# Enhanced EAP-based User Authentication coexisting with PKM based Device Authentication

*Dongkie Lee, DongRyul Lee, DongIl Moon, JongKuk Ahn  
SK Telecom*

1 **3. Proposed Changes to IEEE 802.16e/D2**

Figure 1 Transfer of EAP Master Key

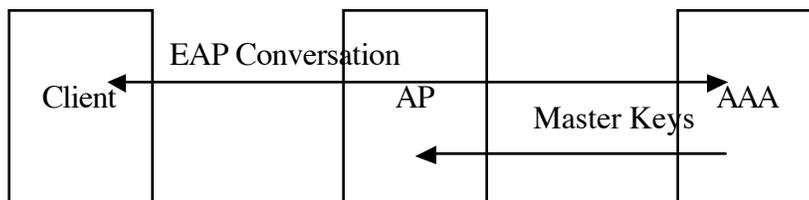
With 802.11 WLAN, several EAP methods are developed and widely used due to the WEP's security weakness. It suffered also from the static key provisioning problem. That's why the so-called Dynamic WEP is introduced to WLAN. With Dynamic WEP, WEP keys are refreshed periodically using EAP-TLS, EAP-TTLS, PEAP, etc. Where Client and AAA negotiate master key, and the master key is sent to the AP from the AAA. Again as mentioned, proliferation of EAP is driven by WEP's static key provisioning problem and security weakness.

But with 802.16, it's a different story. Although, PKM have somethings left to be enhanced, it's quite well defined and does not suffer from the problems of WEP. Public key systems which requires certificates of both sides such as EAP-TLS have suffered deployment and management problems. But with PKM, off-the-shelf SS and BS have embedded certificate and does not suffer from the deployment and management problem. TEK is refreshed periodically and does not suffer from the static key provisioning problem. And PKM does not suffer from the security flaw which is found in WLAN. This is the first reason EAP doesn't need not be tied to or tweaked with PKM.

Secondly EAP-MD5 does not have any master key generation mechanism and cannot be used. If we stick to PKM EAP which is proposed already, EAP-MD5 cannot be used. ANY EAP methods SHALL be supported for user authentication by IEEE standard. EAP-MD5 is not a exception.
